RESPONSES TO QUESTIONS DURING TENDERING

END OF ADDENDUM NO. 3

22) Section 33 65 73 2.8.6

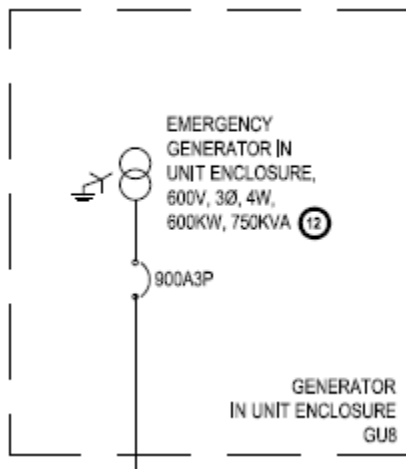
- Can the Oldcastle Synertech 3660 (Stacked) be used in place of the 'Christy' Series? I don't believe a 'Christy' series pull pit is produced in the dimensions requested.

Response: Old castle Synertech is acceptable.

25) Drawing E3-01-01 Detail 15

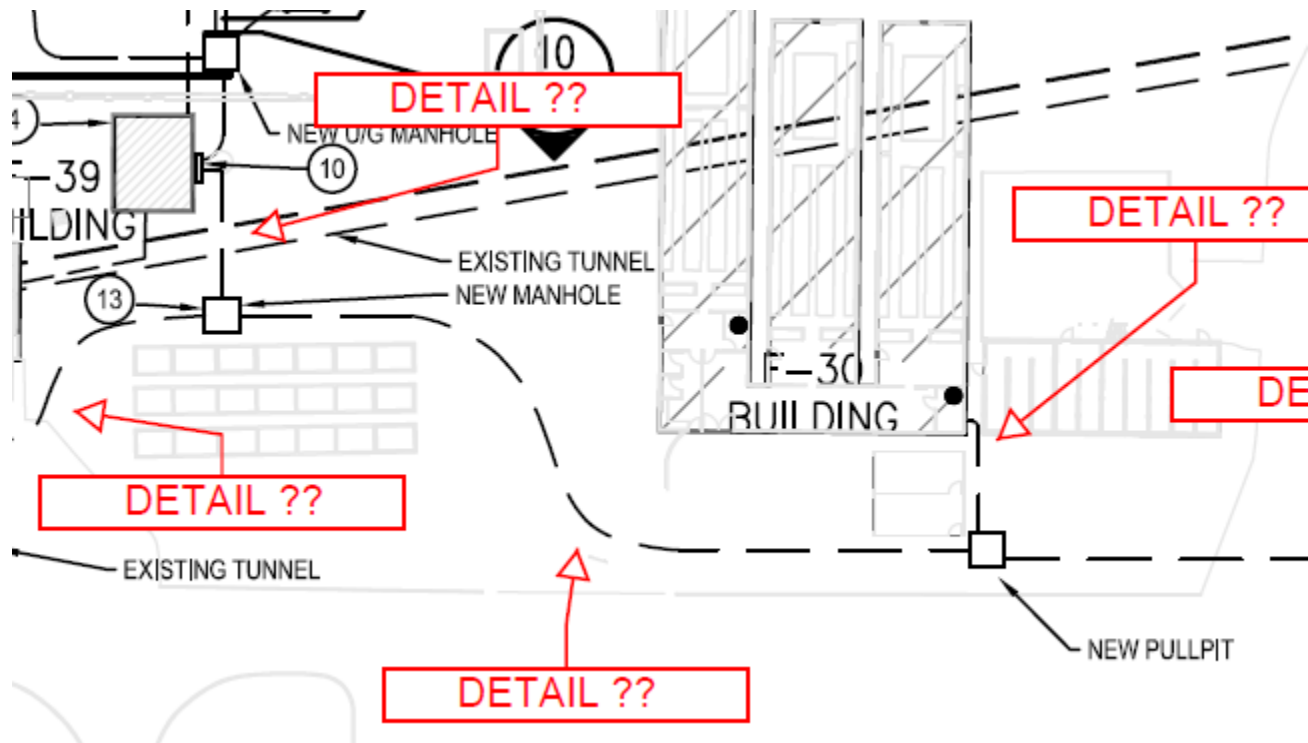
- The housekeeping pad appears to be built on void form and independent of the piles for the panel ... How will this pad stay where it was installed without adequate support?

Response: Detail will be updated for next addendum.
